DATE: February 5, 2014

AGENDA ITEM # 2

TO: Design Review Commission
FROM: Sean K. Gallegos, Assistant Planner
SUBJECT: Modification to 13-SC-16 – 767 Santa Rita Avenue

This project is a modification to an approved new two-story house. The proposed modification maintains the previously approved size of the project and relocates and reduces the size of the second story balcony; relocates bedroom No. 2 from the rear to the front of the house; and revises the landscape plan.

A1.2
 DETAILED FLOOR PLAN

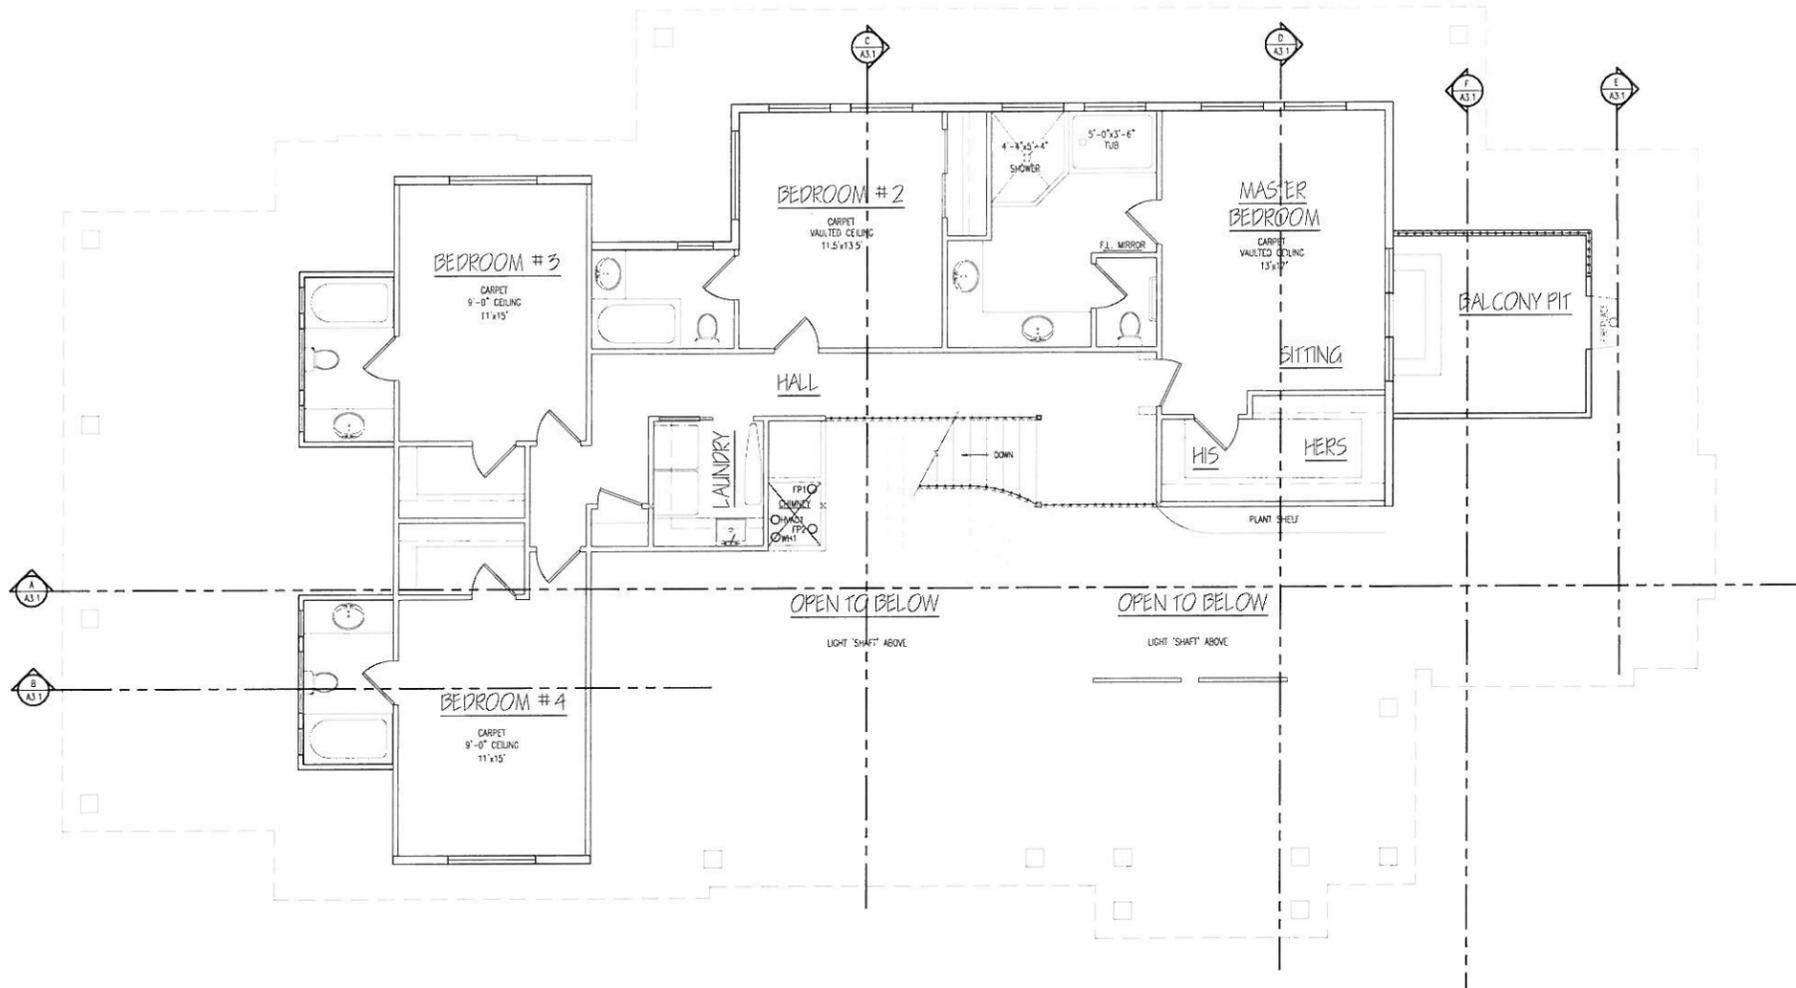
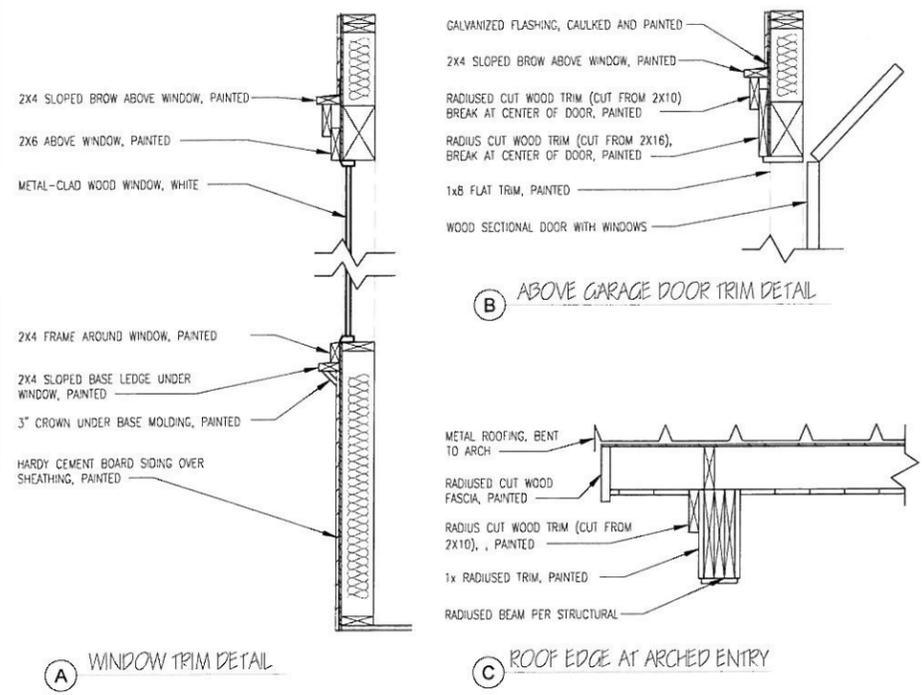
In response to prior Design Review Commission comments regarding massing, the applicant revised the design of the proposed house. The design changes include relocating bedroom No. 2 from the rear of the house to the front of the house. Bedroom No. 2 is tucked into the southwest gable, which was previously the high vaulted ceiling for the entry. Overall, the proposed design has

A2.1
ELEVATIONS

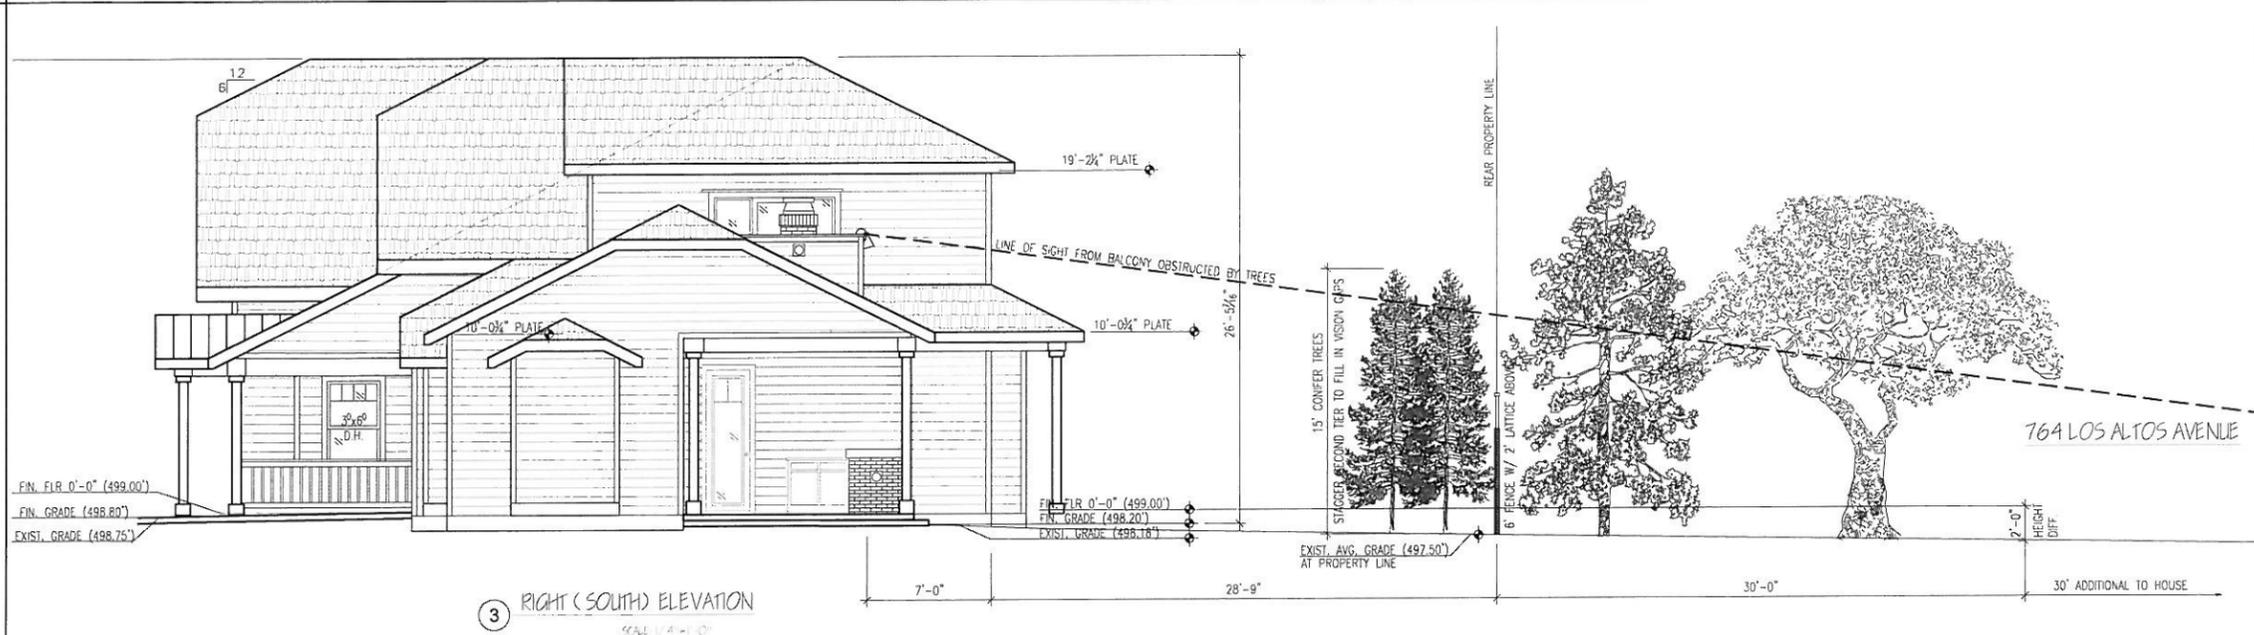
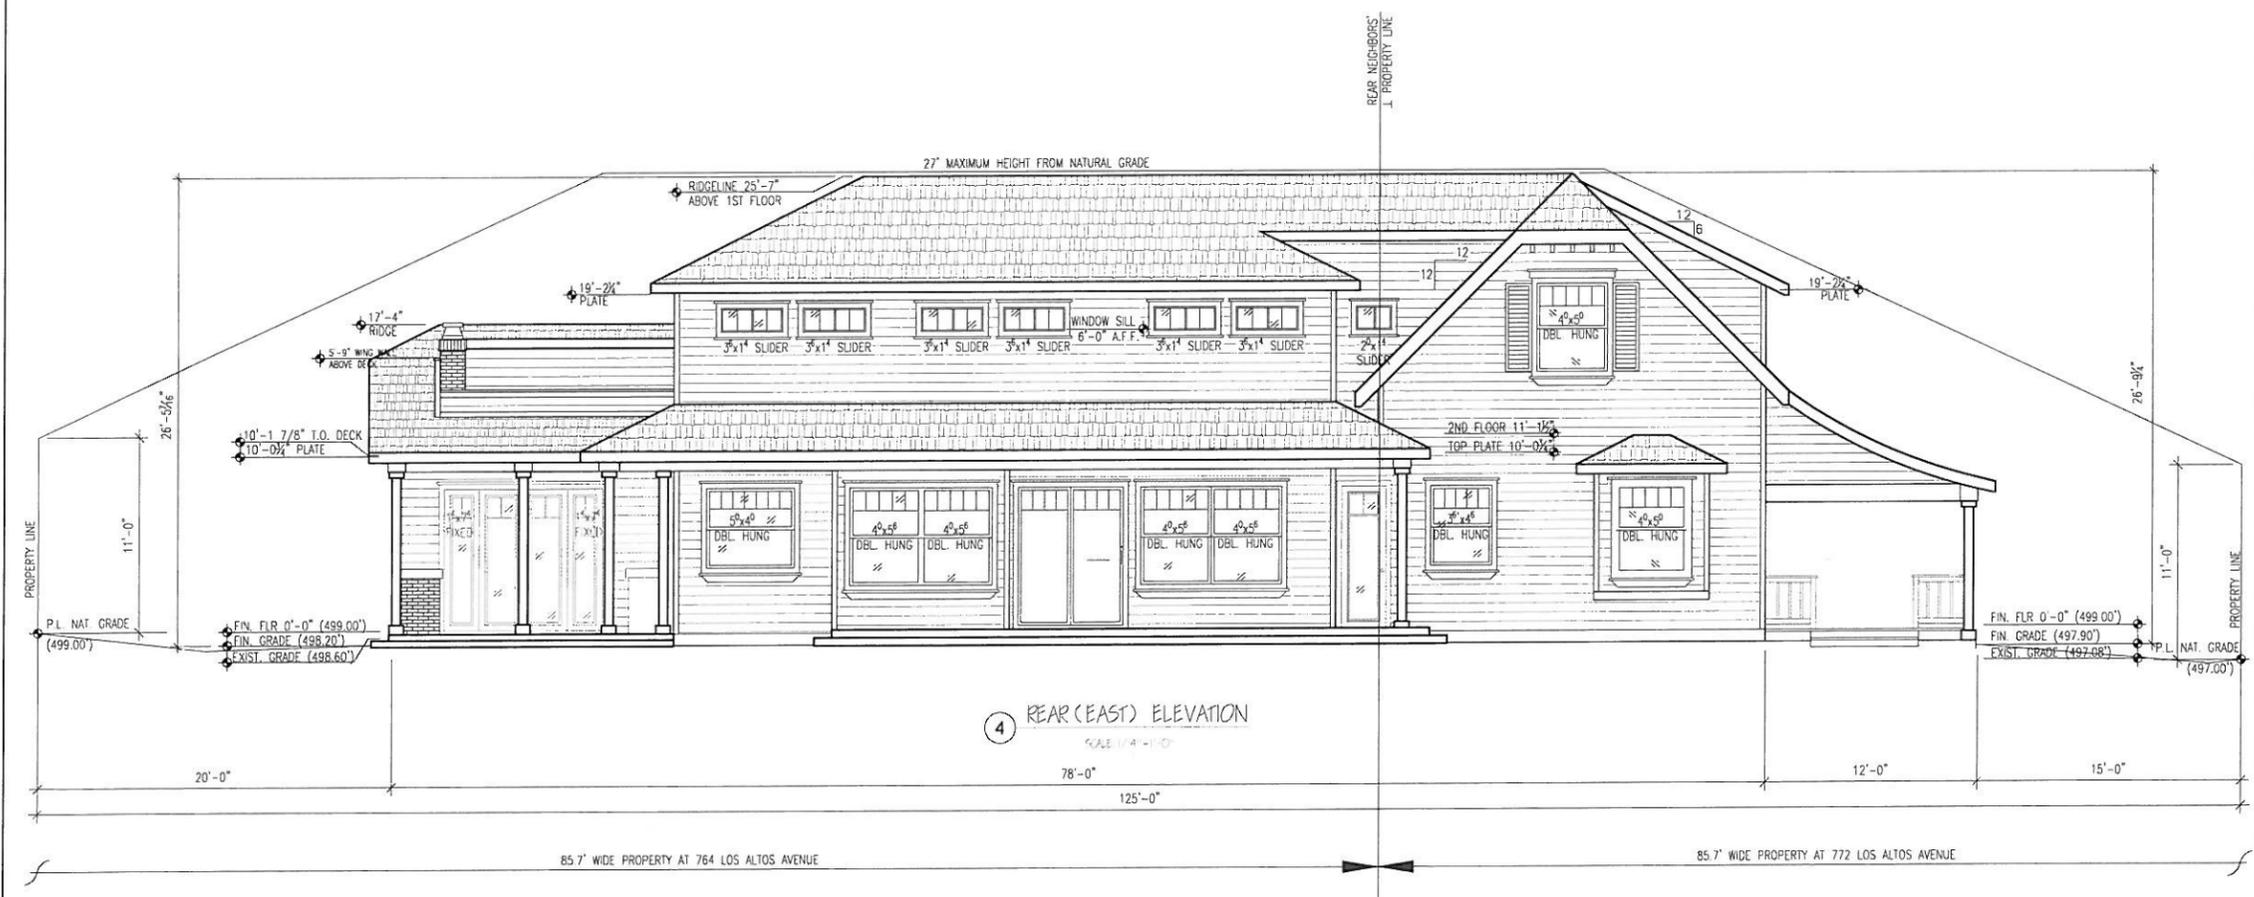
As part of the approval, the Design Review Commission included a condition to remove the 118-square-foot second-floor balcony to reduce privacy impacts along the right side and rear property lines. The modified plan includes a smaller second story balcony (96 square feet), which is recessed between the master bedroom and bedroom No. 3. This design creates a more passive outdoor space and effectively minimizes privacy impacts to right side and rear properties.

As noted in the January 13, 2014 approval and final conditions letter, the Design Review Commission added a condition that the design shall be revised to eliminate the master bedroom's second floor balcony. The applicant has requested that this condition be removed due to the design modifications. Staff agrees that the proposed design has incorporated substantial changes to address the Commission's comments regarding privacy impacts to adjacent properties. Based upon these changes, staff has prepared positive design review findings and conditions of approval for the Commission's consideration to permit a two-story structure with a second story balcony.

Therefore new plans are being submitted as an Amendment to the previously submitted plans. The issues of a.) windows facing the rear neighbors, b.) the bulk and mass of the rear of the house and c.) the privacy issues associated with the balcony have been addressed in a more satisfactory fashion. It is hoped that this effort will constitute a mutually agreeable solution and a beneficial outcome for all community stakeholders will ensue.
